Metrology Reports DQW

R.I Cavity #1 + #2

Results according to CERN metrologies

Cavity #1

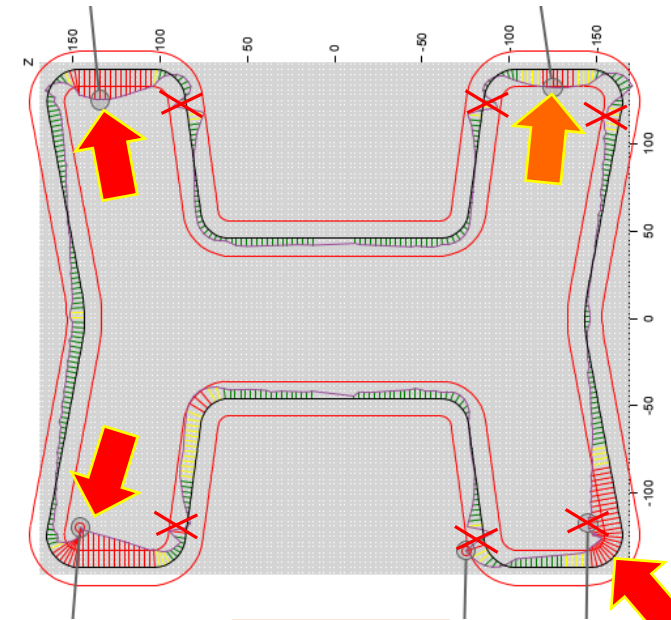
Both cavities are out of tolerances with important offset:

Cavity #1: offset 1.2mm, so 2.4mm tolerance instead of 1.5mm required

Cavity #2: offset 1.75mm, so 3.5mm tolerance instead of 1.5mm required

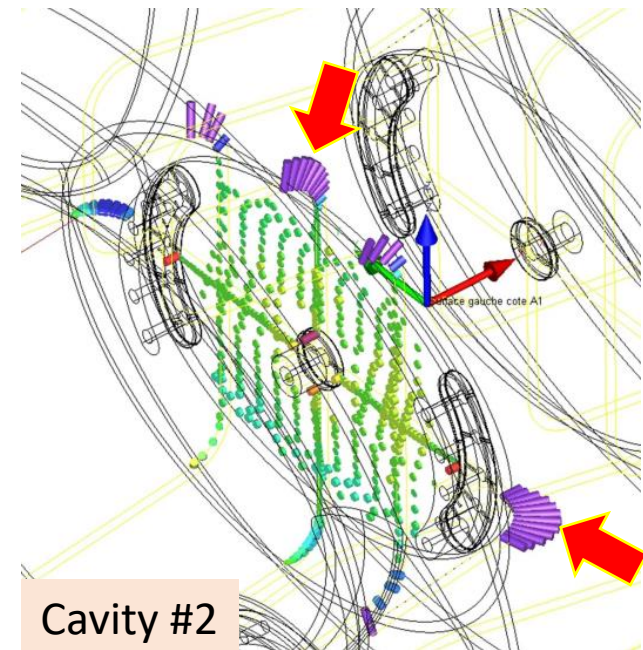
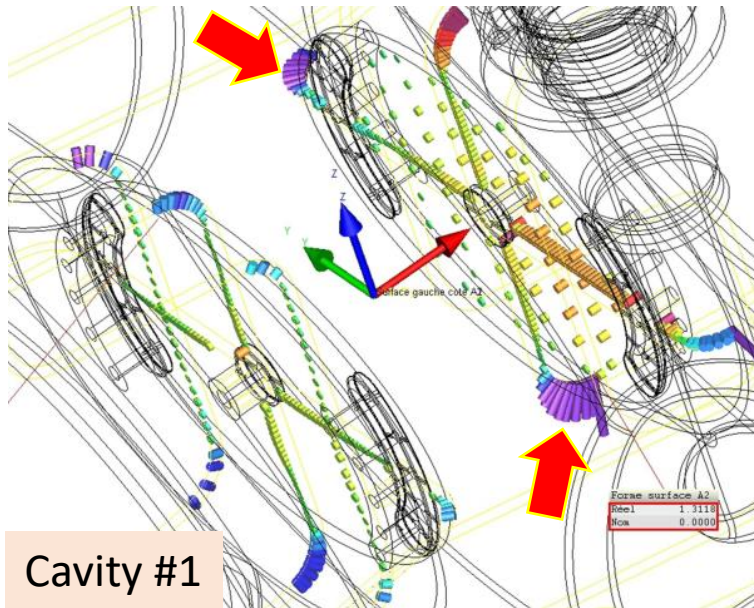
Both cavities are out of tolerances in the pole area:

Cavity #1: 1.31mm instead of 0.6mm required

Cavity #2: 1.55mm instead of 0.6mm required

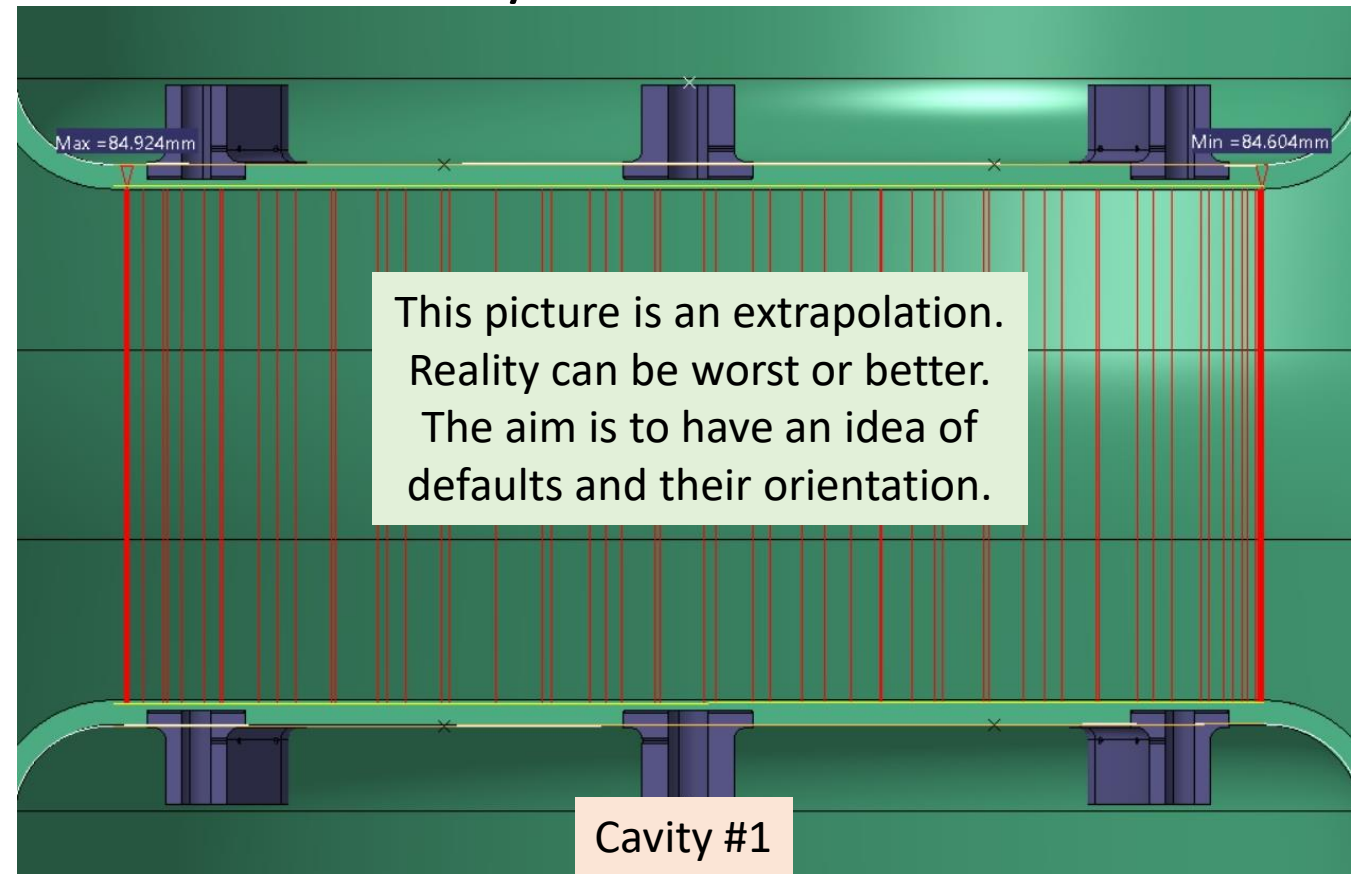
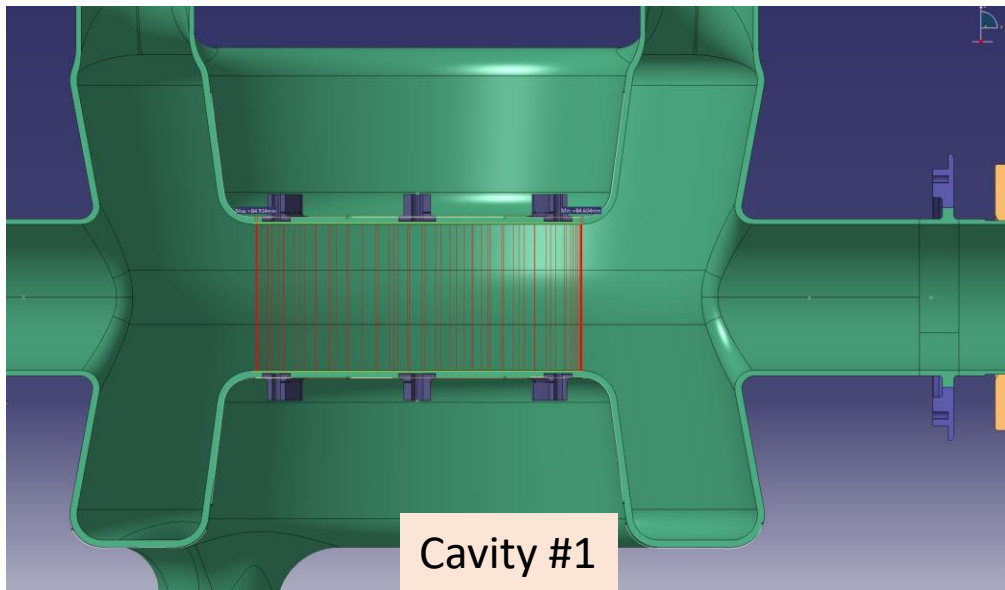
Distance between poles:

Cavity #1: 84.8 mm instead of 83.7mm nominal/84.2mm max

Cavity #2 OK (~83.8mm)

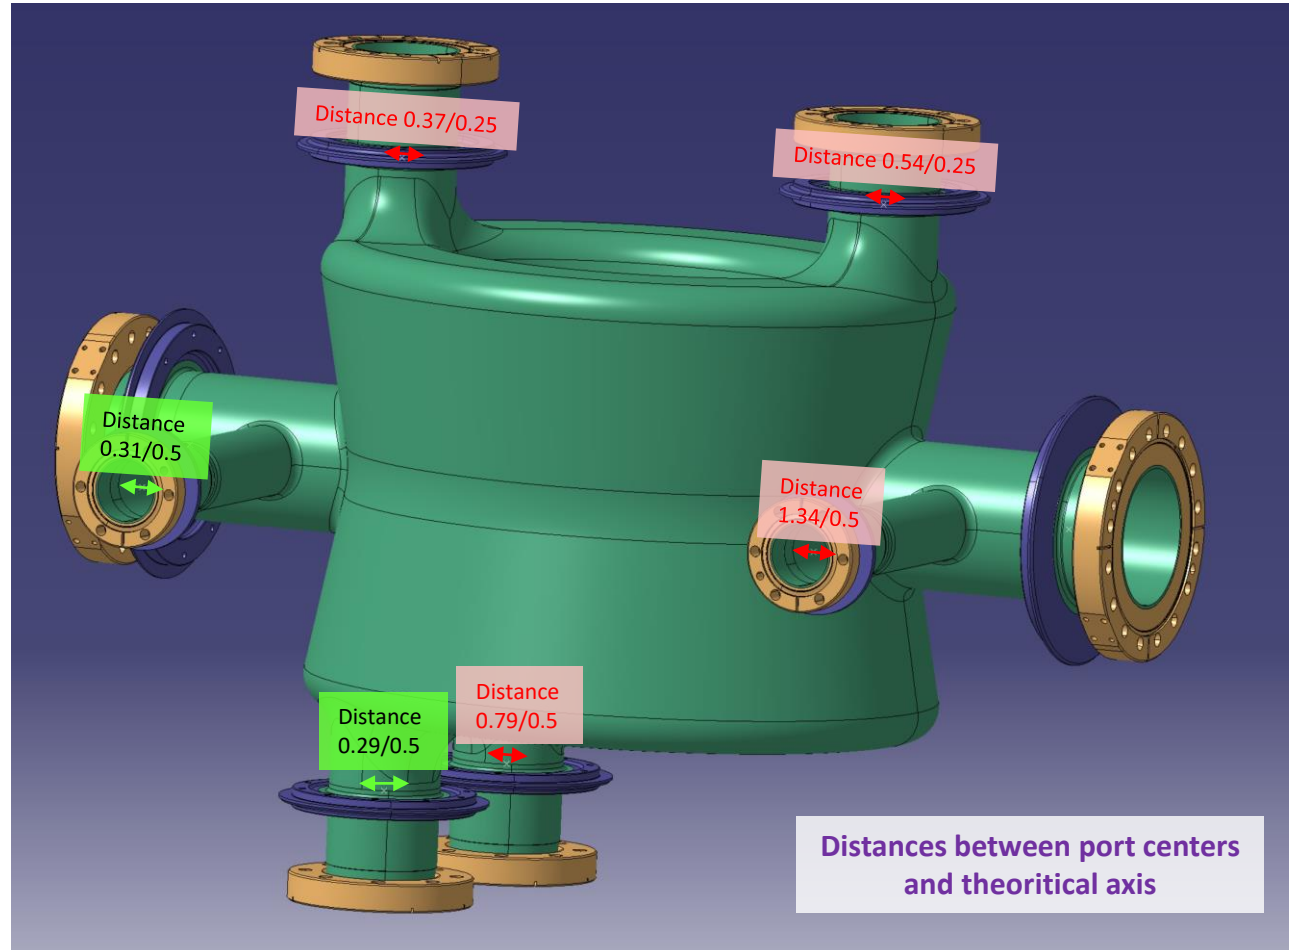
- 1) Trouble for Beam Axis B longitudinal position: 0.92mm offset (shorter). Adaptive rings original design for 0.6mm max. 0.92mm would be feasible but with special care.
- 2) Coaxiality trouble Pick-Up B: 1.3mm offset.
- 3) Coaxiality troubles for FPC and HOMs: 3 out of tolerance. Offset up to 0.8mm.
- 4) Doubts on M5 depth. To be checked and re-thread (spec: 8 min)

CERN: 0.35 max

Need to recalibrate to be able to mount on He Tank. This will significantly decrease forces and deformations on extremities.

Need to do again metrology once calibrations will have been done.

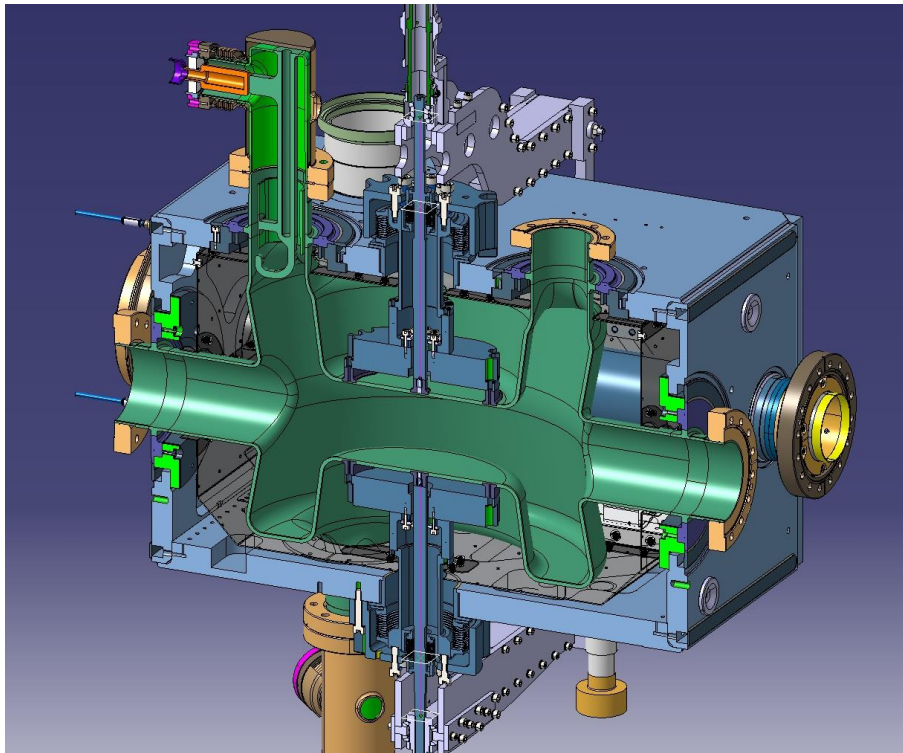
Top Tuning out of tolerance. The errors mix leads to 1.76mm expected radial offset errors for the frame connection, and 1.21mm radial offset for the tuning bellow.

Bottom Tuning out of tolerance. The errors mix leads to 0.69mm expected offset errors for the frame connection, and 0.54mm radial offset for the tuning bellow.

CERN: Top max 1.21mm / Bottom max 0.53

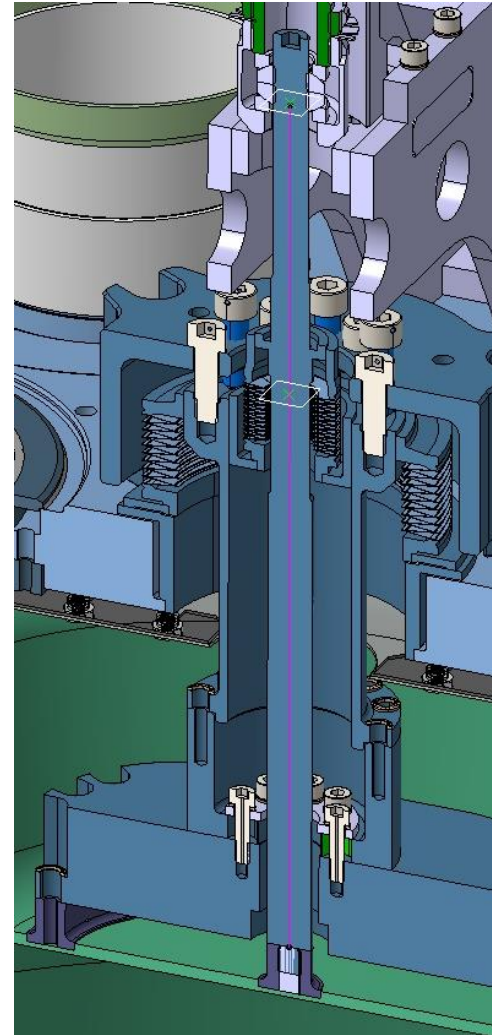
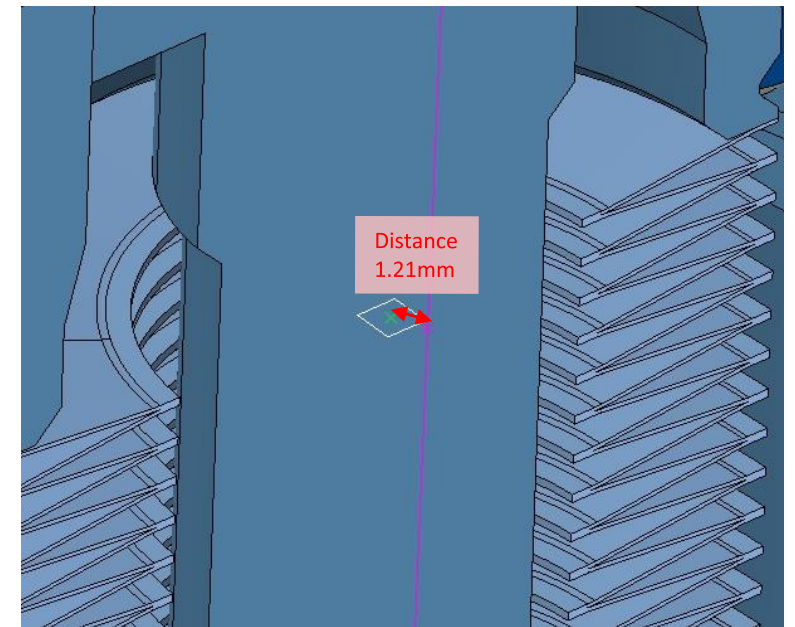
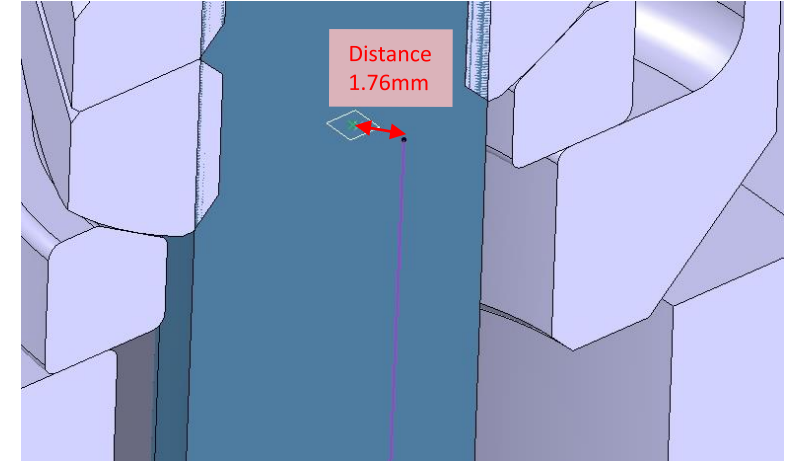
Today, we can't know if the tuning pin's deviations are acceptable or not. We are analysing the feasibility of mounting the tuner.

For cavity #1: Offset and parallelism are not the same between top and bottom. Tuning has to be symmetrical to work properly.

Errors measured are up to x3 specification.

Such deviation is not acceptable for series.

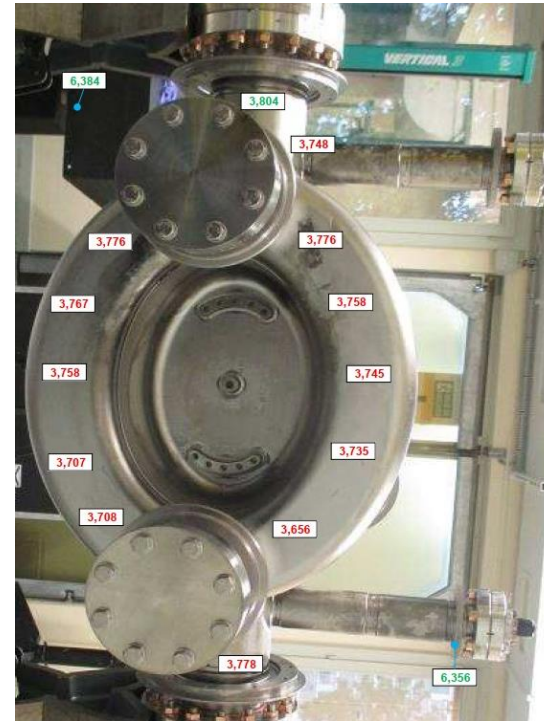
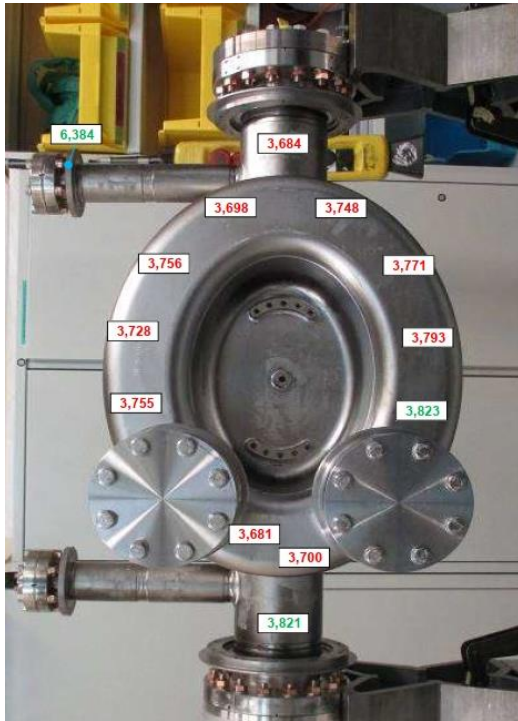
Thickness measurements at the subcomponent level is necessary to garanty the final RF surface's positions. This has to be achieved by external and internal profiles by metrology.

We were not able to find them in your metrology reports.

Cavity #1: thinner than required. Capacitive plates: 0.5/0.6mm less.
Inductive rings: 0.25mm less.

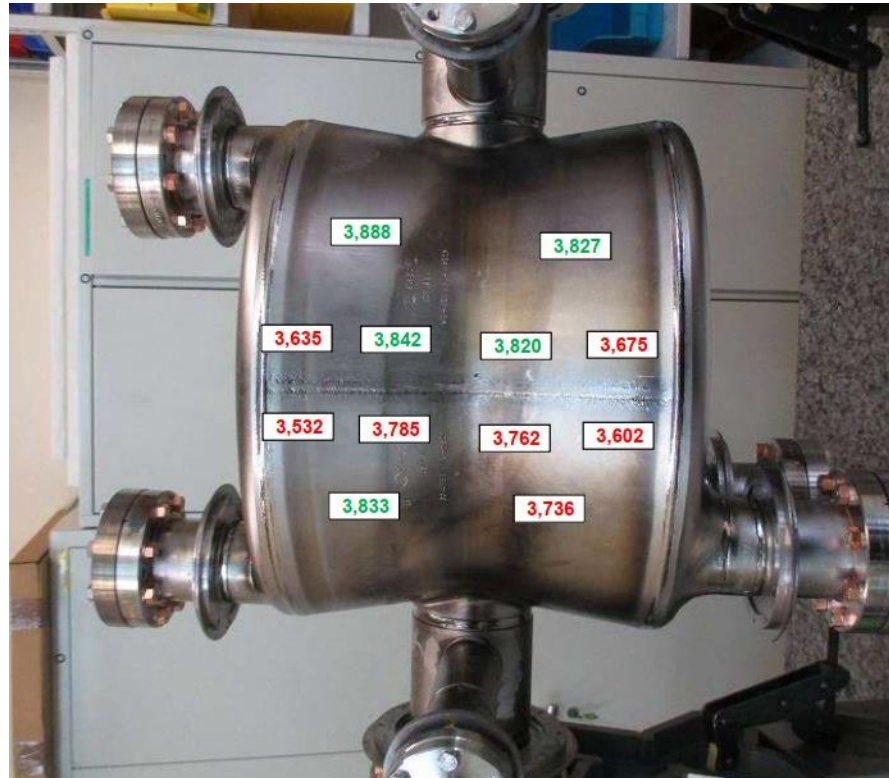
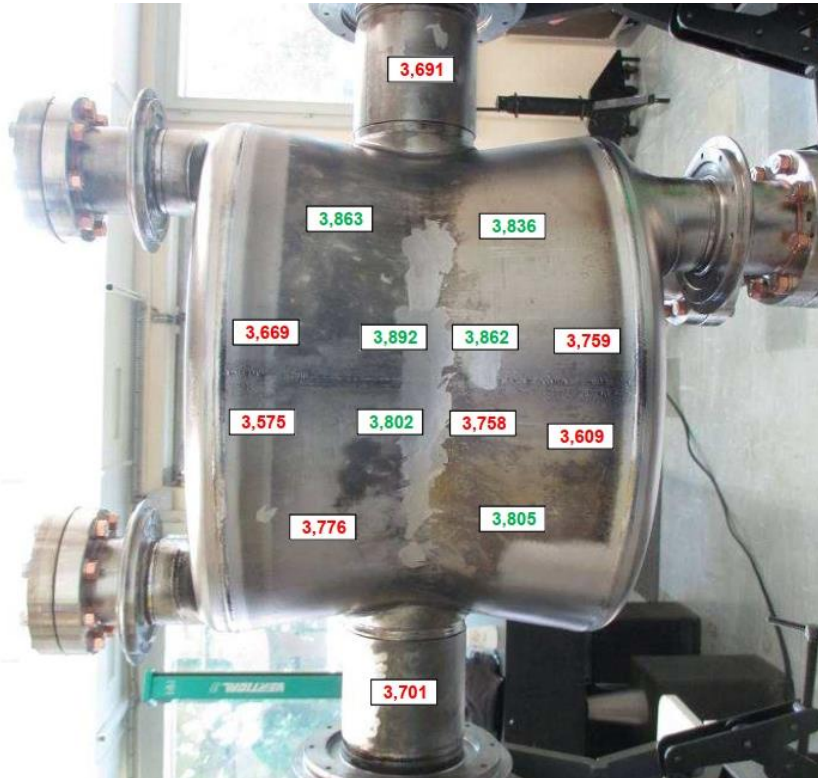
Cavity #1: thinner than required. Main body: ~0.25mm less

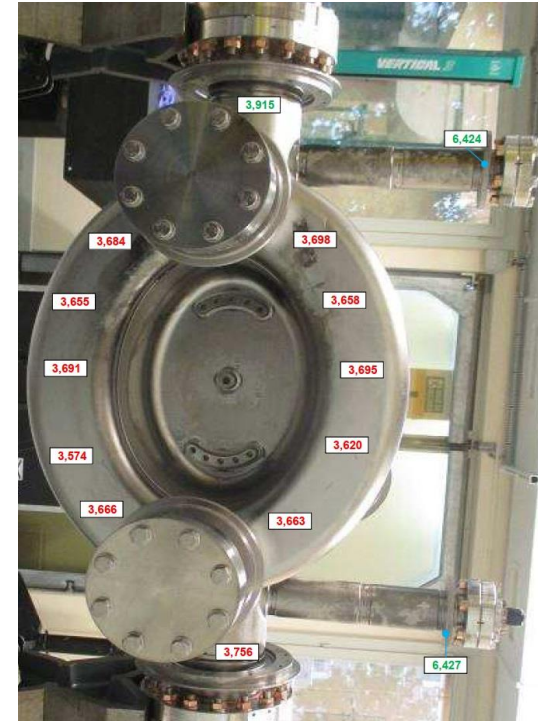
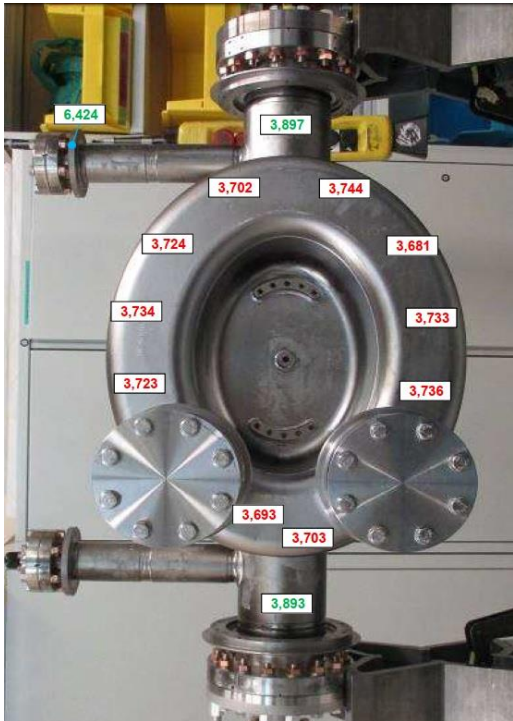
Cavity #2: thinner than required. Capacitive plates: 0.25/0.45mm less.
Inductive rings : 0.3mm less.

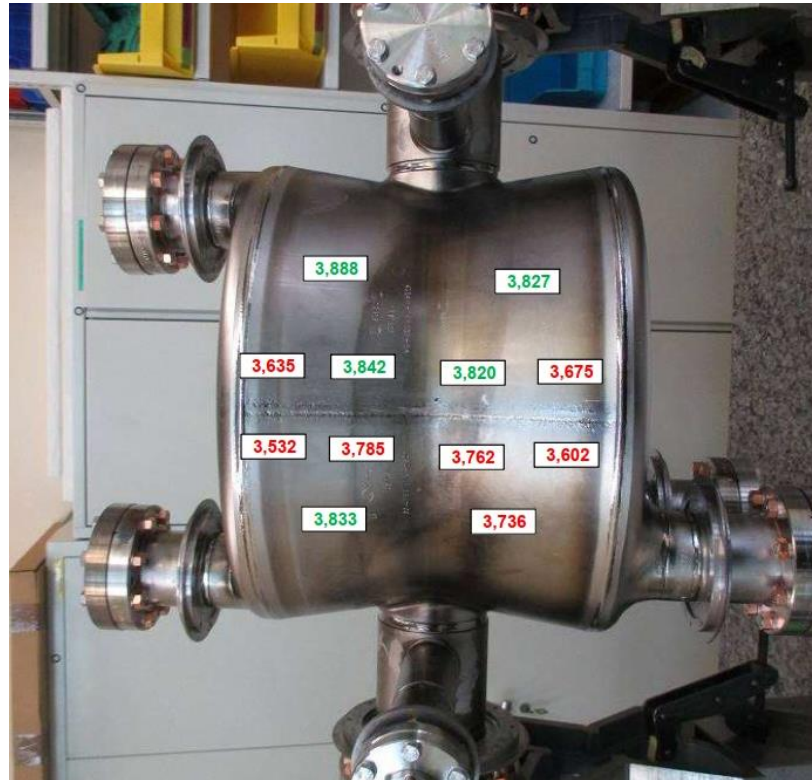
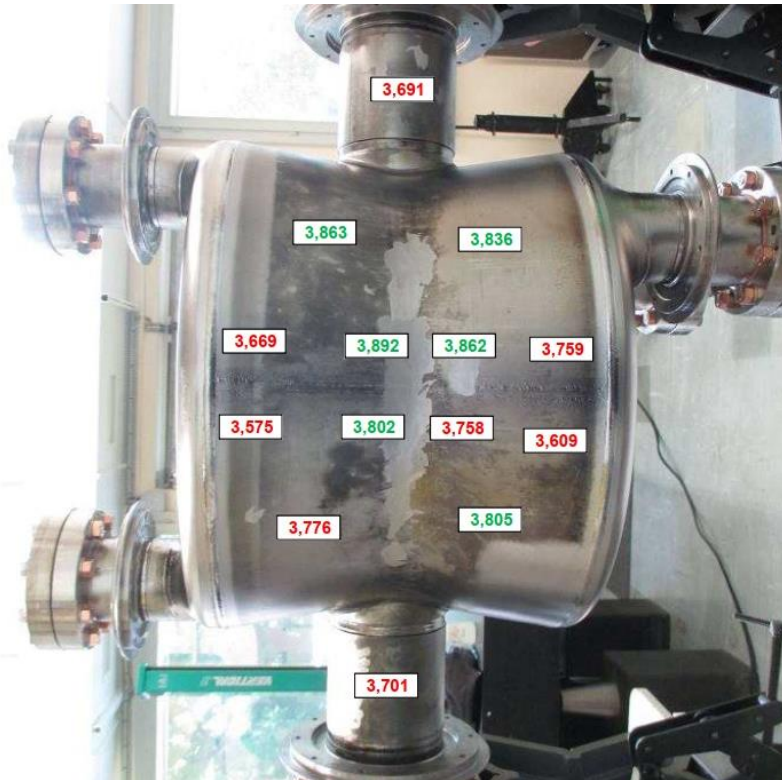
Cavity #2: thinner than required. Main body: ~0.25mm less

Mitigations should be put in place to stay within thickness tolerances for the series.
